NINE MILE POINT NUCLEAR STATION, UNIT NO. 1

AMENDMENT TO FACILITY OPERATING LICENSE

Amendment No. 58  
License No. DPR-63

ATTACHMENT TO LICENSE AMENDMENT NO. 58

FIGURE 3.2.2.a

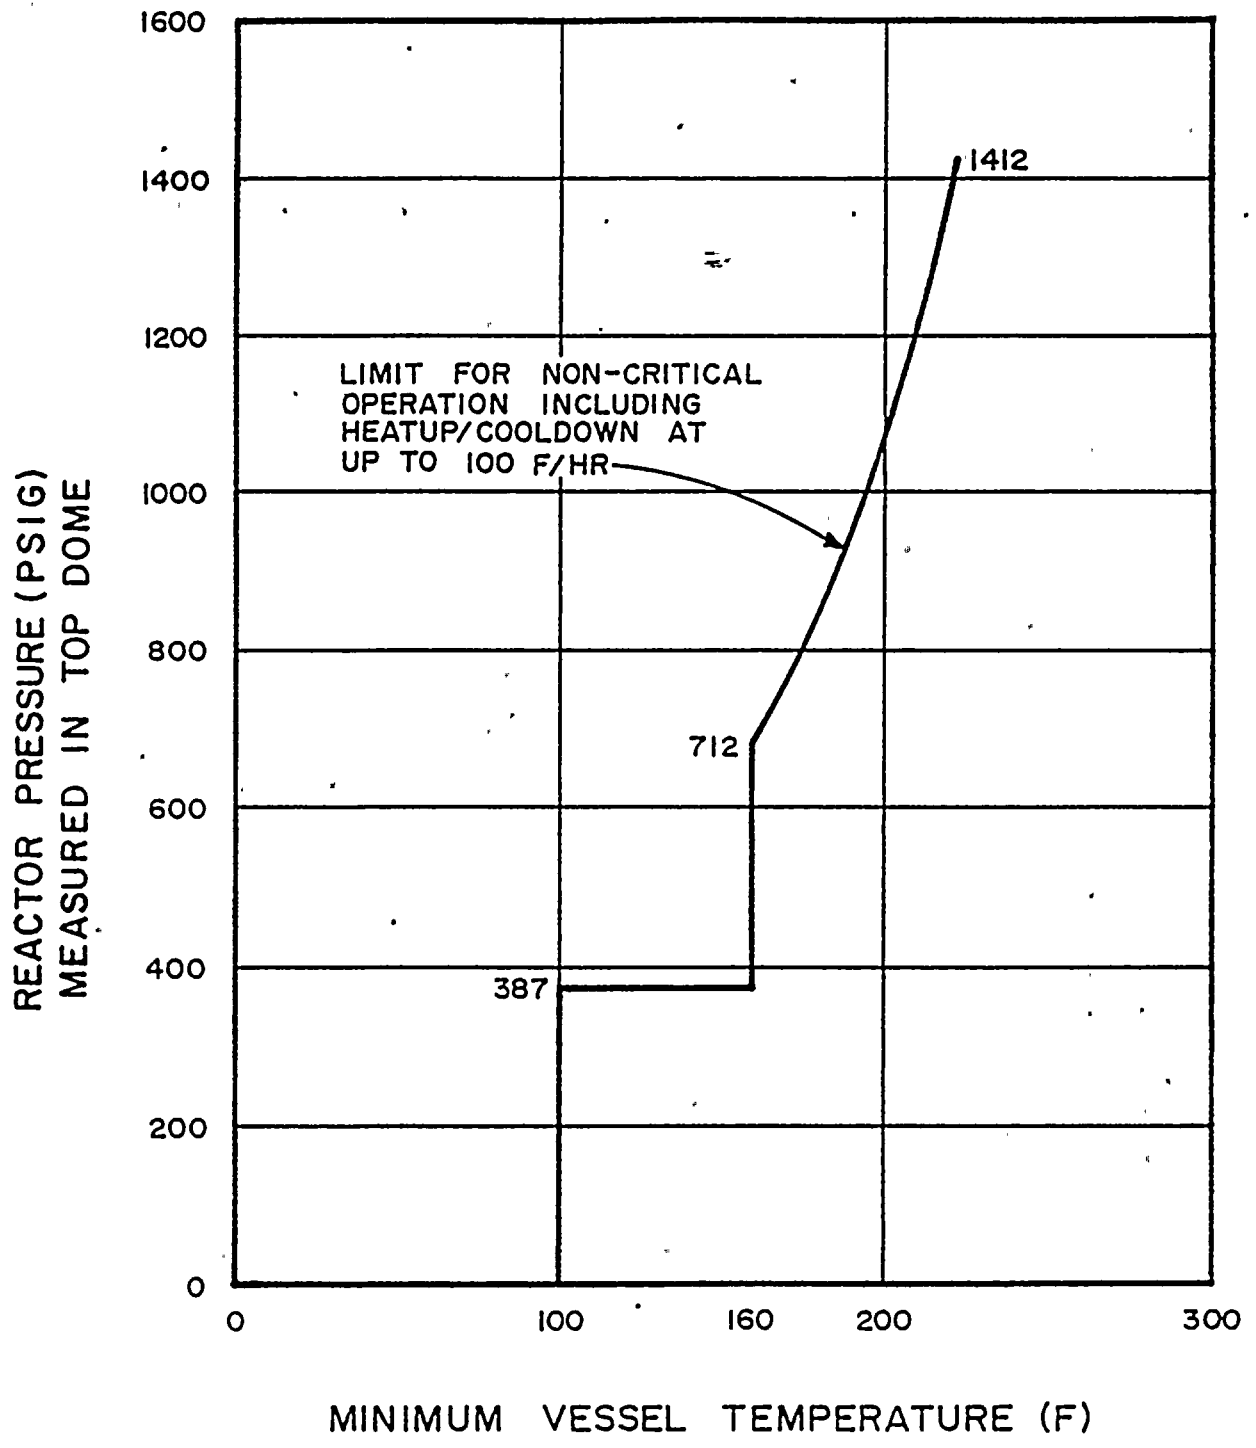
- a. During reactor vessel heat-up and cooldown when the reactor is not critical the reactor vessel temperature and pressure shall satisfy the requirements of Figure 3.2.2.a.
- b. During reactor vessel heat-up and cooldown when the reactor is critical the reactor vessel temperature and pressure shall satisfy the requirements of Figure 3.2.2.b, except when performing low power physics testing with the vessel head removed at power levels not to exceed 5 mw(t).

<u>PRESSURE (psig)</u>	<u>TEMPERATURE (F)</u>
387	100
387	100-160
712	160
762	166
812	172
862	177
912	182
962	187
1012	192
1062	196
1112	199
1162	203
1212	207
1312	213
1412	219

FIGURE 3.2.2.c

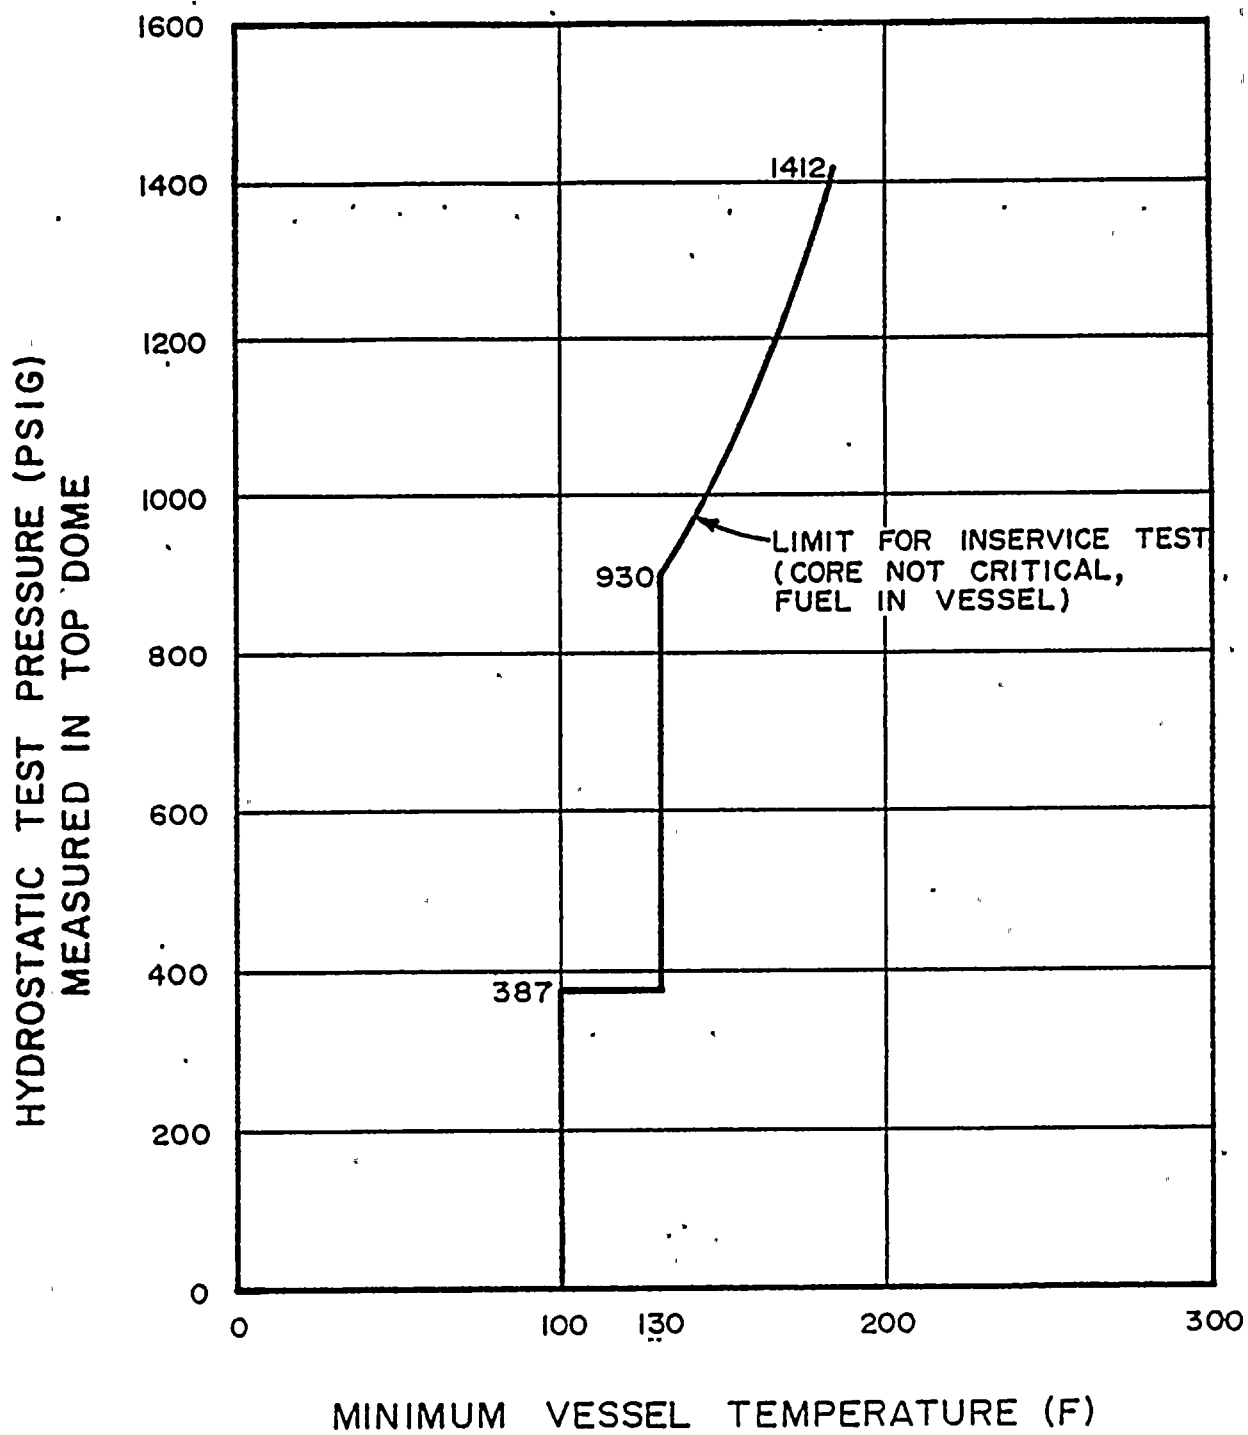
- c. During hydrostatic testing the reactor vessel temperature and pressure shall satisfy the requirements of Figure 3.2.2.c if the core is not critical and Figure 3.2.2.d if the core is critical.
- d. The reactor vessel head bolting studs shall not be under tension unless the temperature of the vessel head flange and the head are equal to or greater than 100F.

<u>PRESSURE (psig)</u>	<u>TEMPERATURE (F)</u>
387	100-130
930	130
962	135
1012	142
1062	148
1112	153
1212	164
1312	173
1412	181
